DEVELOPMENT NO:	22018116
APPLICANT:	Sans Arc Studio
AGENDA ITEM NO:	Item 3.1
ADDRESS:	31 McLaren Street, Adelaide
NATURE OF DEVELOPMENT:	Construct two storey rear addition to existing single
	storey dwelling with associated internal and
	external alterations
ZONING INFORMATION:	Zones:
	City Living
	Overlays:
	 Airport Building Heights (Regulated)
	Affordable Housing
	Building Near Airfields
	Design in Urban Areas
	Historic Area
	Heritage Adjacency
	Local Heritage Place
	Hazards (Flooding - Evidence Required)
	Prescribed Wells Area
	 Regulated and Significant Tree
	Stormwater Management
	Urban Tree Canopy
	Technical Numeric Variations (TNVs):
	Maximum Building Height (Metres)
	Minimum Site Area
	Maximum Building Height (Levels)
LODGEMENT DATE:	6 June 2022
RELEVANT AUTHORITY:	City of Adelaide Council Assessment Panel
PLANNING & DESIGN CODE	2022.9 - 26 May 2022
VERSION:	
CATEGORY OF DEVELOPMENT:	Code Assessed - Performance Assessed

1. DETAILED DESCRIPTION OF PROPOSAL

Figure 9.4.1 – 9am Winter Solstice

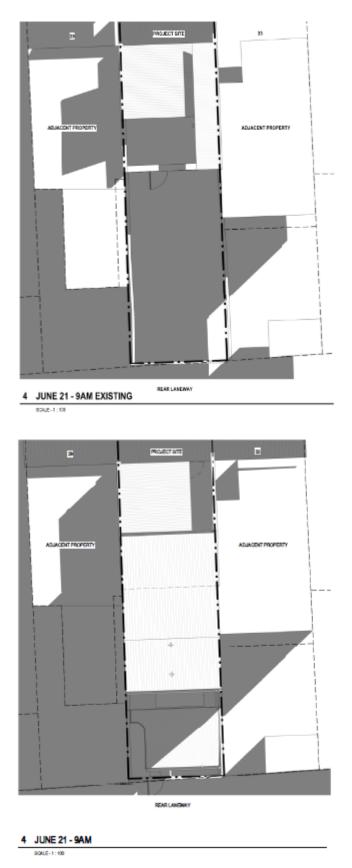
At 9am, there is no change to the extent of overshadowing for habitable room windows or the private open space area to the west at 29 McLaren Street, as shown in Figure 9.4.1, however portions of the roof will be overshadowed.

At midday, the development will not exacerbate loss of light to habitable room windows or private open of either 29 of 33 McLaren Street as shown in Figure 9.4.2.

Figure 9.4.3 – 3pm Winter Solstice

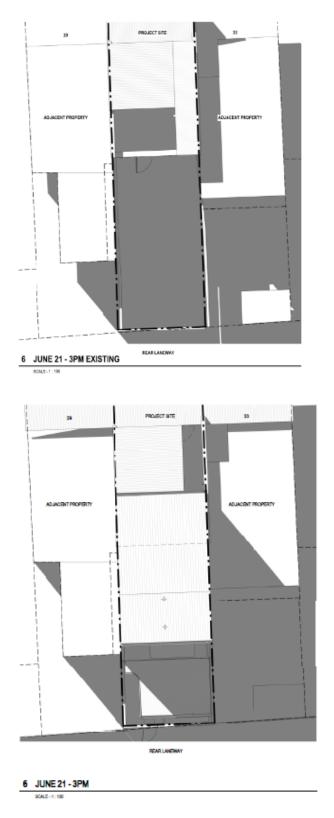
At 3pm, there will be a change to overshadowing of 33 McLaren Street. There is no change to the extent of overshadowing of habitable room windows or the private open space area to the west at 29 McLaren Street as shown in Figure 9.4.3. However, portions of the roof of the dwelling and outbuilding will be overshadowed.

The shadow diagrams demonstrate the adjacent properties to the east and west do not currently receive two hours of direct sunlight to half of the existing ground level private open space areas between 9am and 3pm on 21 June. This proposal will not substantially diminish the current situation nor result in a significant loss of amenity considering the current overshadowing.
